**MONTGOMERY COUNTY HISTORIC PRESERVATION COMMISSION**  
**STAFF REPORT**

<b>Address:</b>	7417 Maple Ave., Takoma Park	<b>Meeting Date:</b>	7/29/2020
<b>Resource:</b>	Contributing Resource <b>Takoma Park Historic District</b>	<b>Report Date:</b>	7/22/2020
<b>Applicant:</b>	David Bend	<b>Public Notice:</b>	7/15/2020
		<b>Tax Credit:</b>	No
<b>Review:</b>	HAWP	<b>Staff:</b>	Michael Kyne
<b>Case Number:</b>	37/03-20CCC		
<b>PROPOSAL:</b>	Window replacement

Maple Avenue Facing Adult Bedroom (Two Windows)

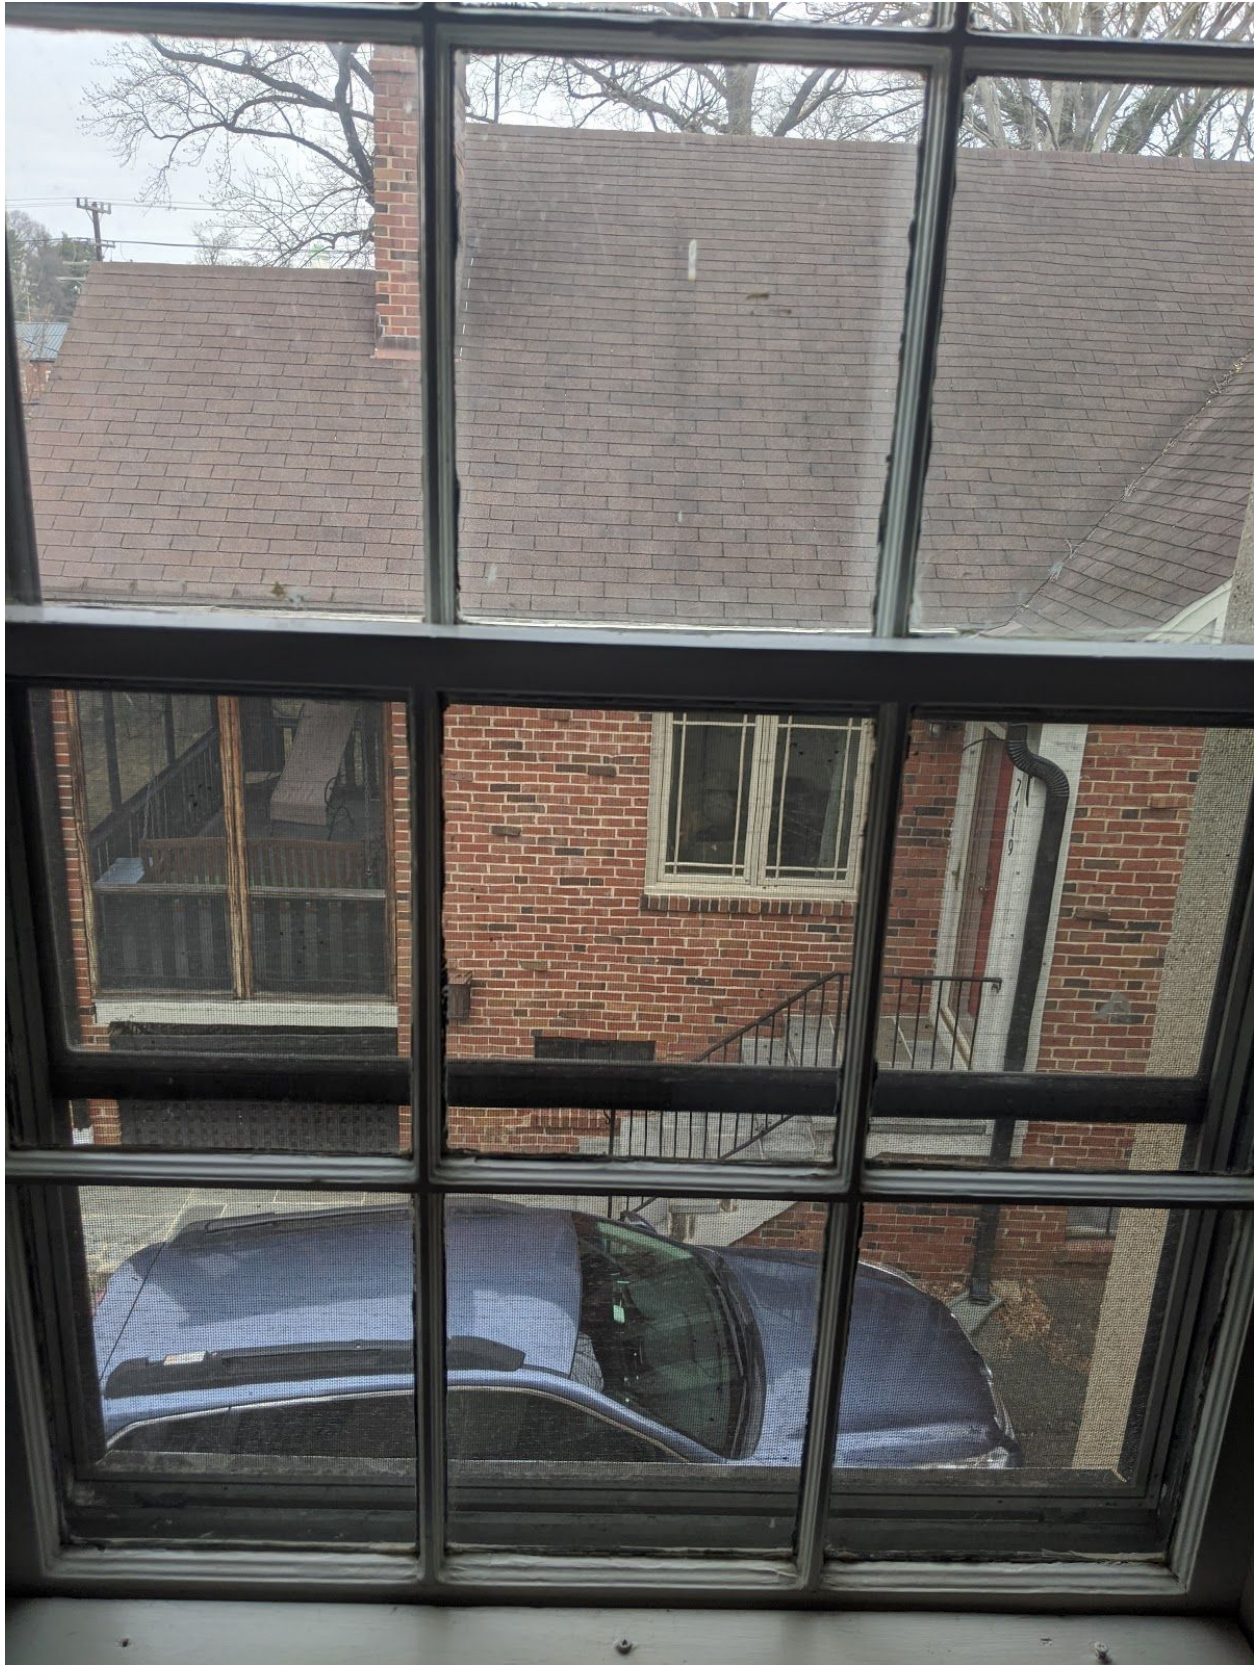
- Conditions assessment
  - The window is extremely energy inefficient and leaks cold and warm air into our home. The window is also cracked. In addition, the leakiness makes the room very noisy and since we live on a busy street it makes it difficult to sleep in the room.

After review of the additionally submitted information, staff continues to recommend that the existing upper floor windows be repaired (and the lead paint stabilized) rather than replaced, in accordance with the *Guidelines* and *Standards*. This recommendation is based upon staff’s observations regarding the condition of the windows proposed to be replaced during the February 19, 2020 site visit, as well as LeadProbe, Inc.’s recommendations, HUD’s *Guidelines for the Evaluation and Control of Lead-Based Paint Hazards in Housing (2012 edition)*, and the National Park Service’s *Preservation Brief 37: Appropriate Methods for Reducing Lead-Paint Hazards in Historic Housing*. Staff’s recommendation is also consistent with the recommendations of the Home Energy Audit that the applicant had performed by Atlas Home Energy on February 28, 2018, although energy efficiency alone is not ground for replacement of original materials and/or features.
